HISTORIC AND DESIGN REVIEW COMMISSION

November 16, 2022

HDRC CASE NO: 2022-538
ADDRESS: 402 QUENTIN DR
LEGAL DESCRIPTION: NCB 7059 BLK 8 LOT 10 E 35 OF 9
ZONING: R-6, H
CITY COUNCIL DIST.: 7
DISTRICT: Monticello Park Historic District
APPLICANT: David Montejano/MONTEJANO VERONICA GARCIA & DAVID
OWNER: David Montejano/MONTEJANO VERONICA GARCIA & DAVID
TYPE OF WORK: Rear patio enclosure
APPLICATION RECEIVED: October 06, 2022
60-DAY REVIEW: Not applicable due to City Council Emergency Orders
CASE MANAGER: Claudia Espinosa

The applicant is requesting a Certificate of Appropriateness for approval to enclose the existing, rear patio.

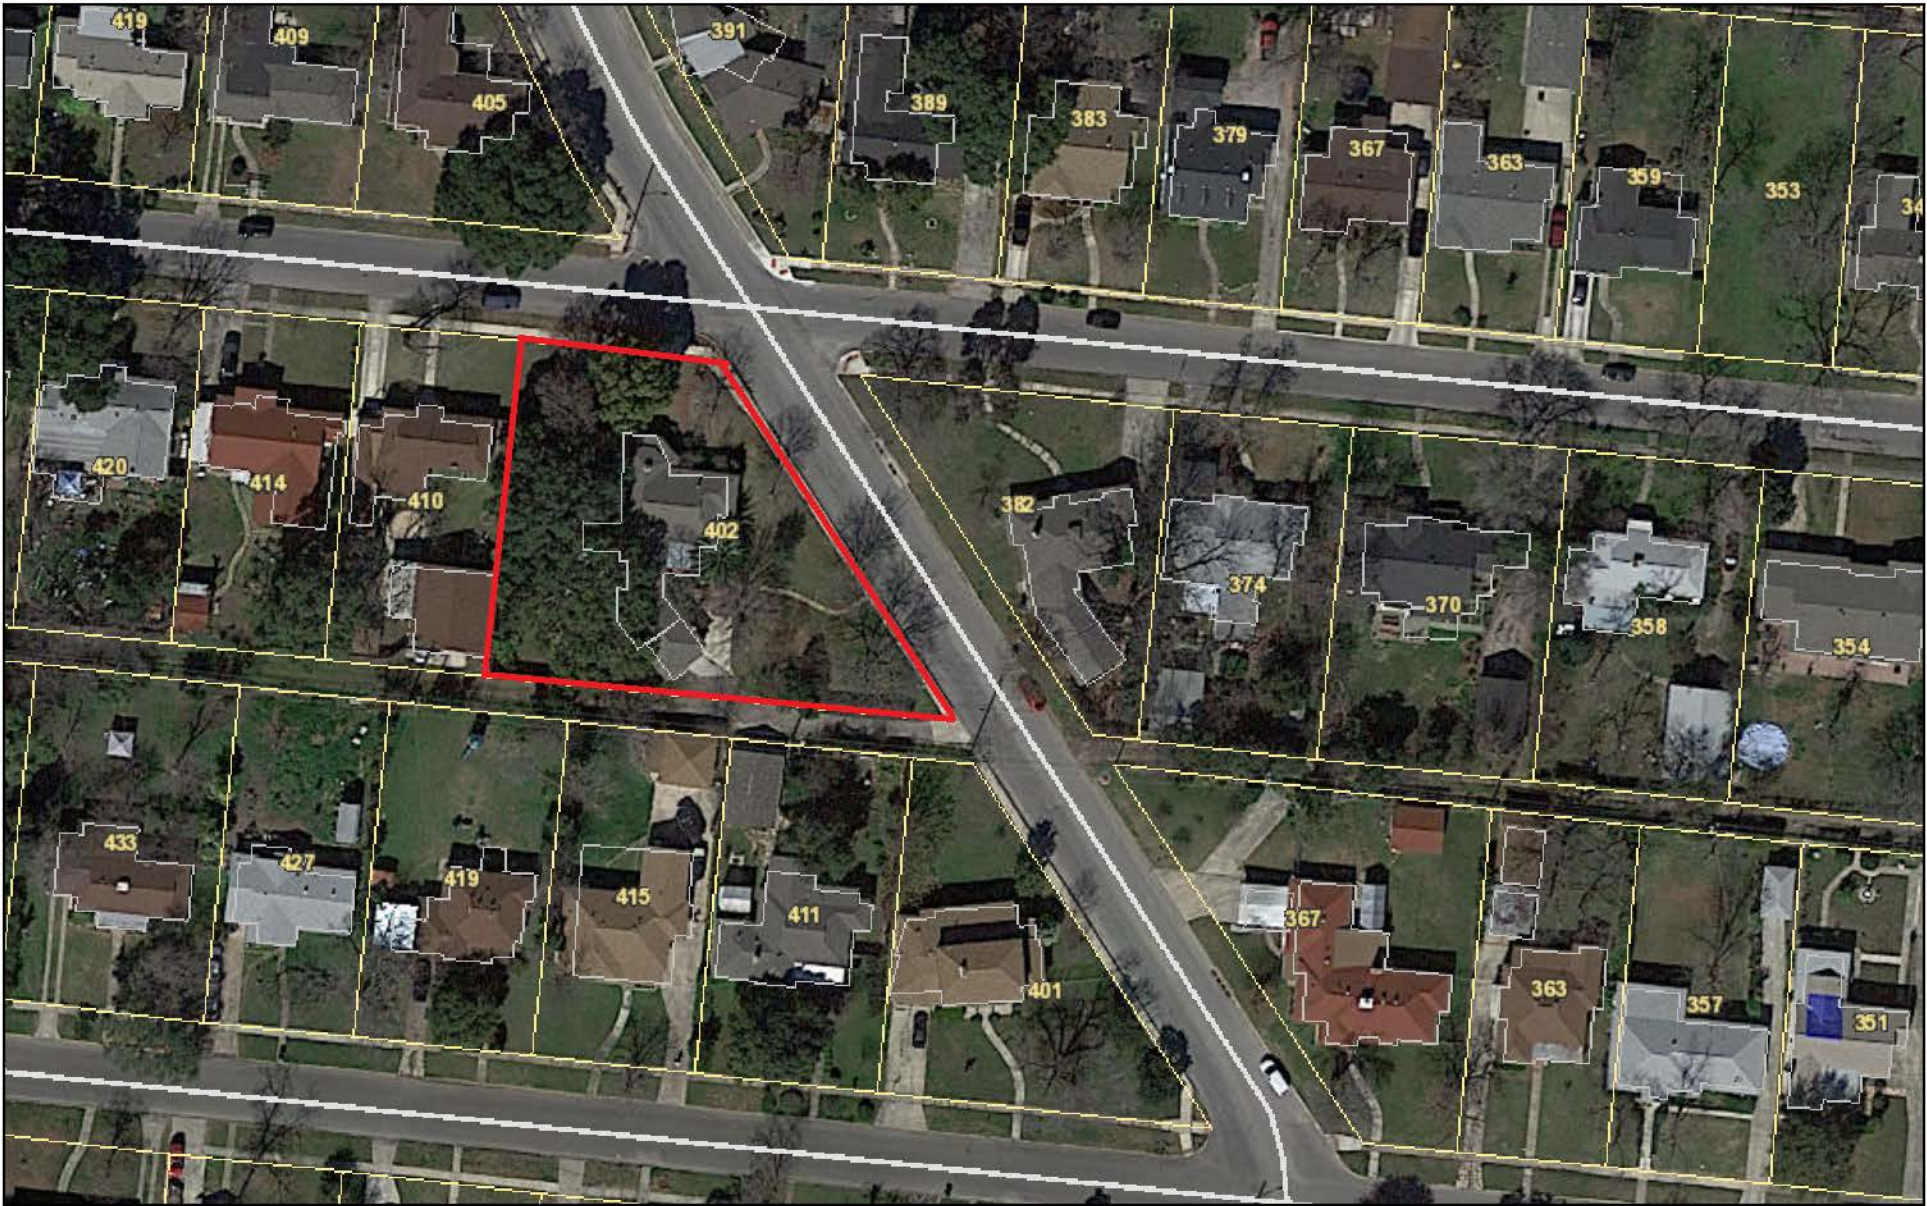
- d. PATIO COVER (Materials) – The applicant has proposed materials that include steel columns, corrugated metal on the lower and upper portions of the enclosure, screened window features, and a screened door with metal framing. The Guidelines for Additions 3.A.i. state to use materials that match in type, color, and texture and include an offset or reveal to distinguish the addition from the historic structure whenever possible. Any new materials introduced to the site as a result of an addition must be compatible with the architectural style and materials of the original structure. Staff finds the proposed materials to be inappropriate. Staff finds that the applicant should use materials typically found in the neighborhood such as wood posts, wood framing, and standing seam metal or shingled roofing materials rather than the proposed materials.

Staff does not recommend approval based on the materials to be used. Staff recommends the applicant construct a patio with a wooden frame, posts, and appropriate roofing materials based on finding d. The enclosed patio should also be fully reversible and not damage the façade.
